CHANGES FROM SCHEME PERMITTED UNDER
ABP-307415-20:

Contextual section 3A-3B - Permitted & Proposed

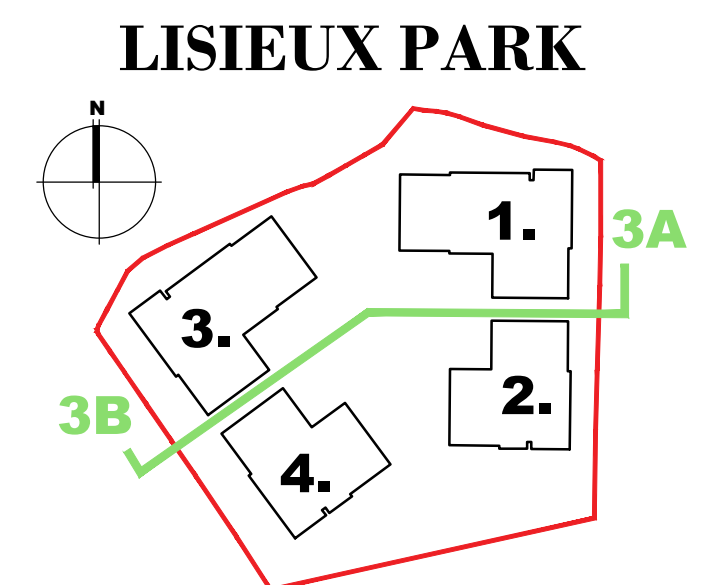
- (1) ALL PERMITTED BEDROOM DOORS
OPENING ON TO BALCONIES CHANGED
TO WINDOWS TO IMPROVE SAFETY
AND SECURITY.
- (2) PERMITTED GLAZED ATRIUM AT ROOF
LEVEL (ABOVE STAIR AND LIFT CORE)
REMOVED FOR FSC PURPOSES
- (3) GLAZED LINK CORRIDORS BETWEEN
BUILDINGS REMOVED
- (4) FENESTRATION SHOWN IN ELEVATION
TO TALLY WITH PERMITTED PLANS
- (5) LINK BETWEEN BUILDINGS REMOVED
AND 2 NEW WINDOWS ADDED IN ITS
PLACE
- (6) MINOR CHANGES TO FENESTRATION
TO ACCOMMODATE IMPROVED
APARTMENT FLOOR PLANS
- (7) NON-STRUCTURAL COLUMNS OMITTED
FROM BALCONIES TO IMPROVE
DAYLIGHT INTO APARTMENTS
